Technology Inclusive Content of Application Project Public Meeting

October 5, 2021
Microsoft Teams Meeting
Bridgeline: 301-576-2978
Conference ID: 968 028 925#

Overview of NRC Comments on NEI 21-07, Rev 0

NEI 21-07 Rev. 0 Technical Report “Technology Inclusive Guidance for Non-Light Water Reactors”

Figure 3-4. Use of the F-C Target to Define Risk-Significant LBEs

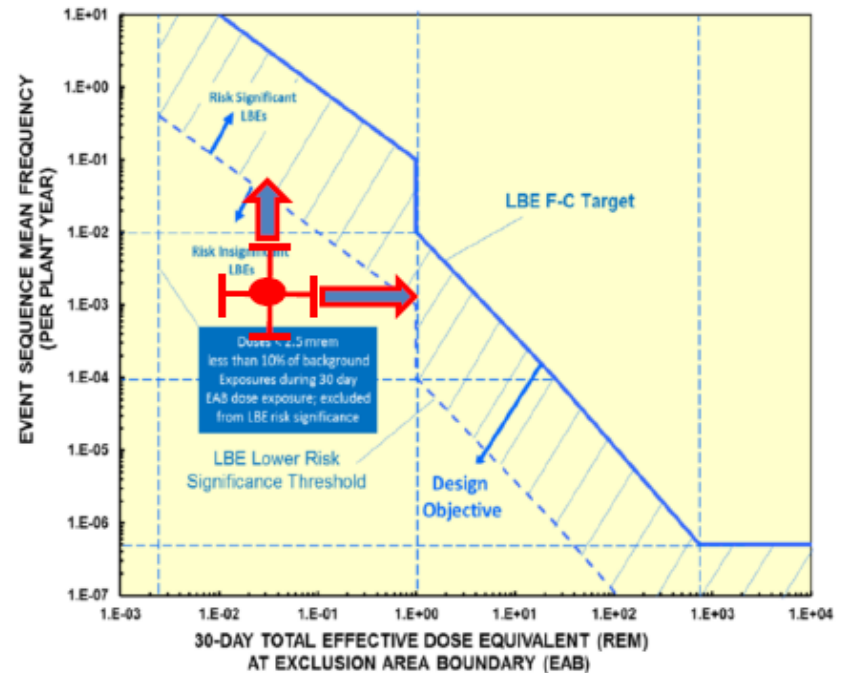
- Three exceptions associated with the level of detail in the safety analysis report (SAR) for anticipated operational occurrences (AOOs), design basis events (DBEs) and beyond-design-basis events (BDBEs) that have radiological releases

- The SAR should include a description of the models, site characteristics, and supporting data associated with the calculation of the mechanistic source terms and radiological consequences (to the extent such information is not provided in Section 2.2) for AOOs, DBEs and BDBEs

- The following is the basis for the exception:
 - The models, site characteristics, and supporting data associated with the calculation of the mechanistic source terms and radiological consequences for AOOs, DBEs and BDBEs are essential elements used in the safety case establishing the design bases or in the safety analyses.
